## **Appendix I**

### Consolidated Responses to Comments

## 2. RESPONSES TO DEPARTMENTAL COMMENTS

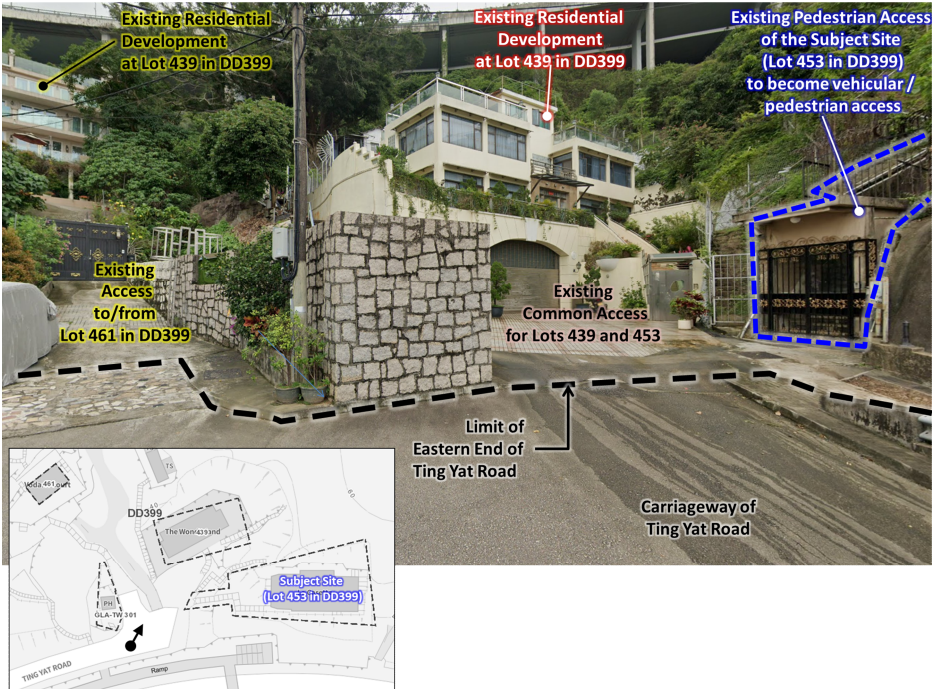
LU(3)	Landscape elevations and sections should be provided to illustrate the spatial quality of the landscape area and the relationship with the surroundings.	Noted. Landscape elevation and section are provided (see <b>Plan P</b> and <b>Plan Q</b> ).
LU(4)	With reference to "Slope Maintenance Responsibility Information System" (SMRIS), there are some registered slopes within the Applicant Site (6SE-D/FR154(1), 6SE-D/CF178(1), 6SW-D/CR424, 6SE-D/C423(2) & 6SE-D/R137). Please indicate the slope boundary and proposed treatment on the relevant plan(s), figure(s) and paragraph(s).	Noted. The registered slopes within the application site have been indicated on <b>Plan O</b> . The proposed tree protection measures during the construction process are added in Section 3.2.
